SINGAPOREAN NOTICES TO MARINERS

I AFFECTED CHARTS AND PUBLICATIONS

Block for Chart No 501

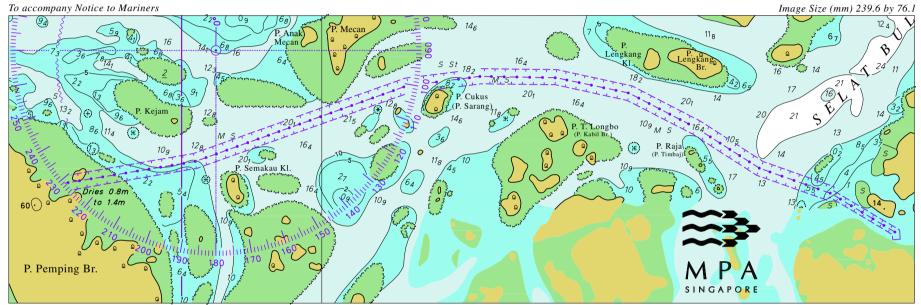
(Pushidrosal Indonesian Notice No. 4	11/456/2023)	
Insert	the accompanying block, centred o	n:	1°06·39'N	103°50·96'E
